Product Change Notification

PCN#: 237

Change Title: Product Process Change

FOX ELECTRONICS
 F5L-F / F5L-4F SERIES
 OLD AND NEW PACKAGES

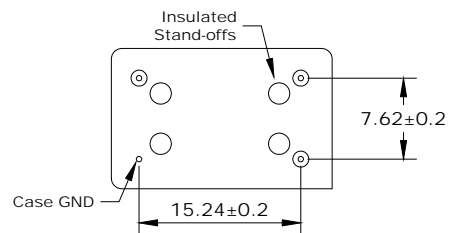
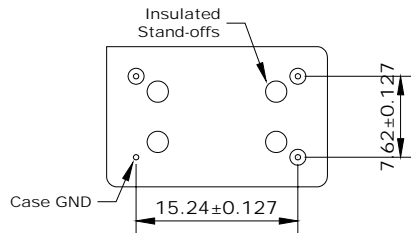
Description of Change to the Customer: Due to an industry wide, sudden unavailability of 14 PIN DIP bases with pin 1 corner designation and pin 14 case GND, we are changing to a package with pin 8 corner designation and pin 14 case GND. Pin numbers and functionality are unchanged. See the attached outline drawing showing the difference from old package to new.
